US 62536917-01

Air duct on the lower triple clamp is missing

Vehicles affected**E series**

K18/11

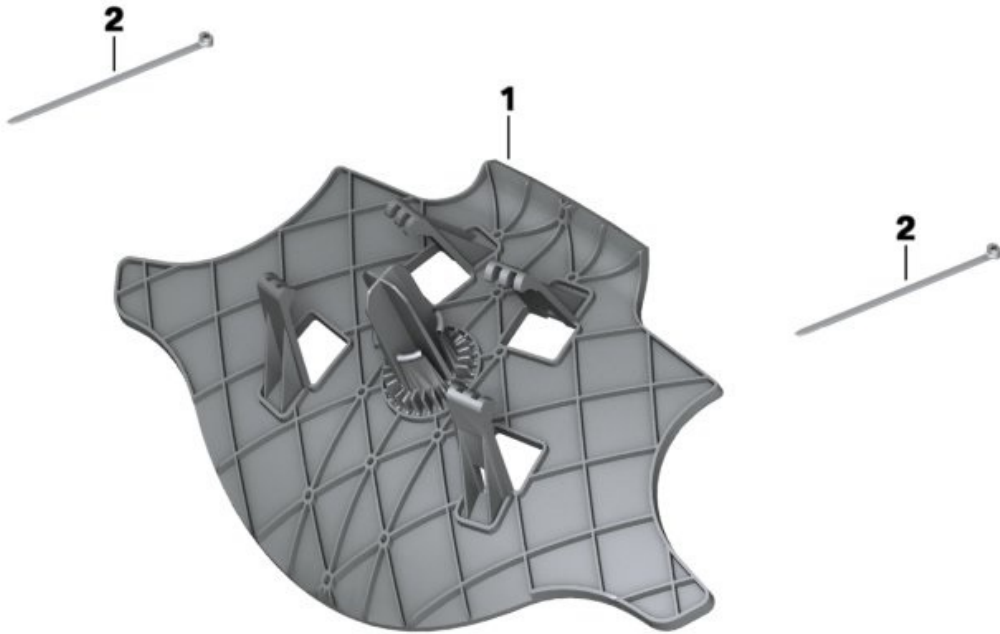
The air duct on the lower triple clamp is missing.

The air duct 46 63 7 725 148 is deleted for the C 650 Sport (K18/11).

Retrofitting of the air duct is not necessary and cannot be invoiced on warranty.
